Subject: Billabong Creek Environmental Water Regulators (SSI-50831979)

ATTACHMENT A – BCS assessment summary for Billabong Creek Environmental Water Regulators Environmental Impact Statement (SSI-50831979).

ATTACHMENT B – Detailed advice for Billabong Creek Environmental Water Regulators Environmental Impact Statement (SSI-50831979).

ATTACHMENT A BCS Assessment Summary for Billabong Creek Environmental Water Regulators Environmental Impact Statement (SSI-50831979)

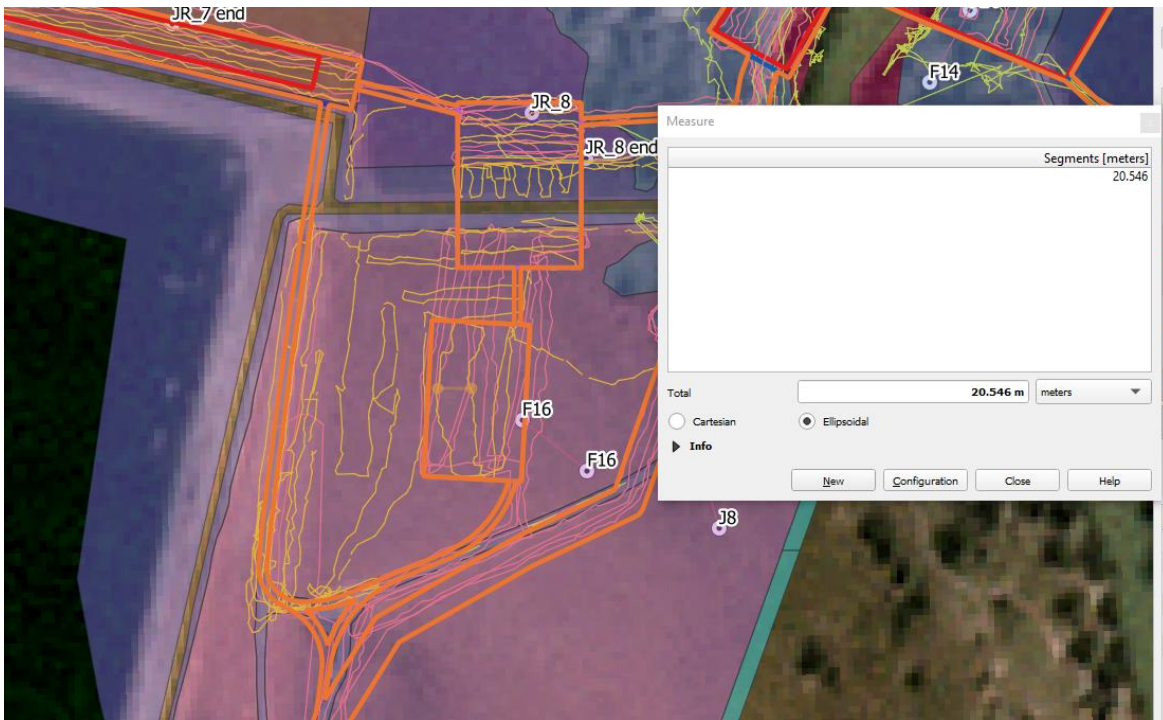
4. Flora threatened species target surveys should be conducted in accordance with relevant guideline and Threatened Biodiversity Database Collection (TBDC)

Table 5.3 of the BDAR states that systematic threatened flora traverses were undertaken for target flora species in September 2022, September and December 2023 with surveys consisting of 5-10 metre spaced traverses.

Threatened species surveys must be conducted as per section 5.3 of the BAM, which requires surveys to comply with the Department's threatened species survey guides and the TBDC. Section 4.2 of the *Surveying threatened plants and their habitats: NSW survey guide for the Biodiversity Assessment Method* outlines the maximum distance between parallel field traverses per life form and vegetation density. The guideline states that the maximum distance between traverses for herbs and forbs within open vegetation is 10m. The spatial data package presents distances wider than the recommended maximum distance (see Figure 1). Any variation from the recommended maximum distance should be documented and justified in the BDAR. If adequate justification cannot be provided, additional surveys or a report from a species expert, or assumed presence may be required.
